ALDERON IRON ORE CORP.

AMENDMENT TO THE ENVIRONMENTAL IMPACT STATEMENT VOLUME 3 APPENDICES – INFORMATION REQUEST RESPONSES

Information Request No. NRCan 07 (Labrador)

Alderon Response to IR No. NRCan 07 (Labrador)

CROSS SECTION A'-A'

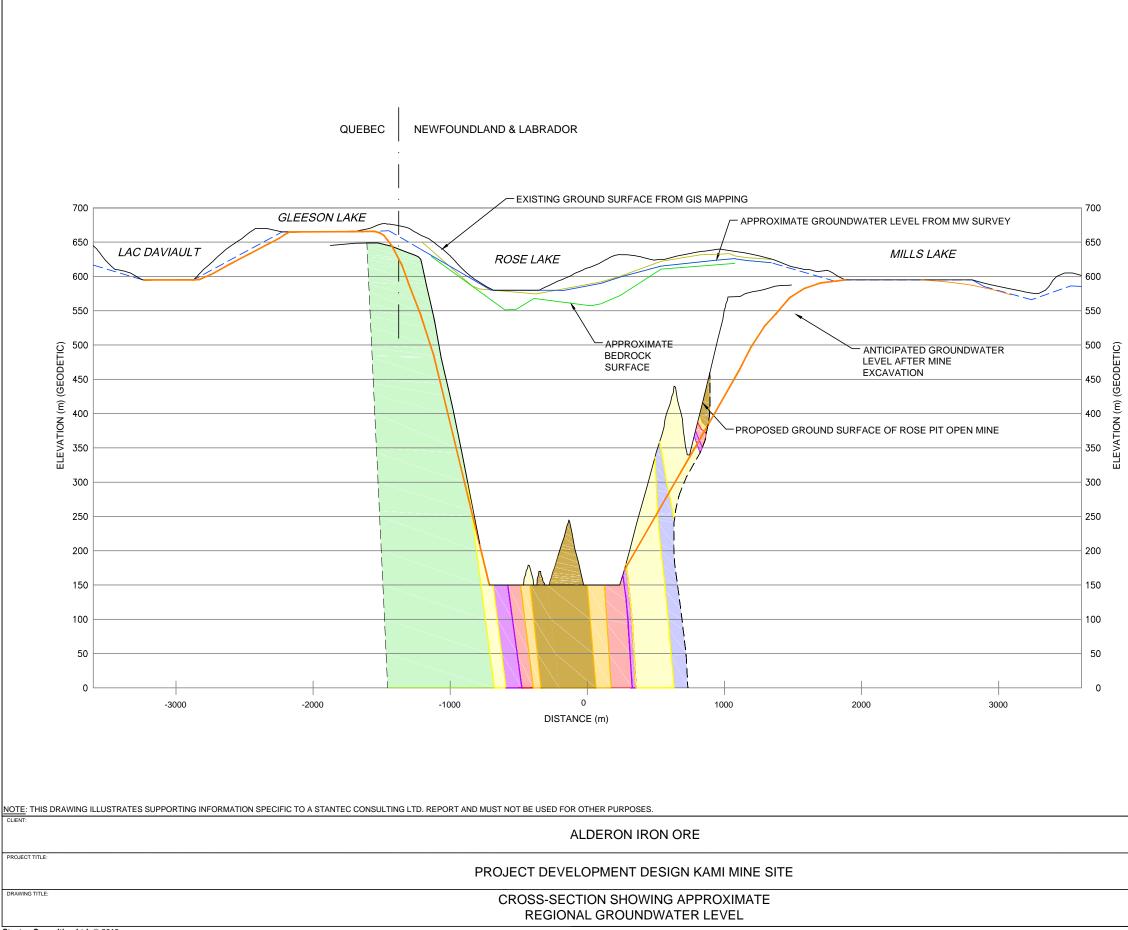
- b) NRCan recommends that accurate estimates of hydraulic conductivity (K) in the vicinity of Rose Pit be calculated.
- c) It is recommended that the cross-section of Appendix A (of Appendix G) be improved so as to integrate geological formations, as well as existing wells and boreholes. Its location should be shown on one of the maps.

The cross section presented in Drawing No. 121614000-306-GE-06; REV. 1, has been revised and updated as requested with information on bedrock geology and the location of the cross section through the pit is depicted in the inserted plan view. Drawings showing the geological data and locations of the existing wells and boreholes that were used to generate this cross section are attached to this response (Drawing Nos. A1-1, A1-2, A2-1, and A3-1).
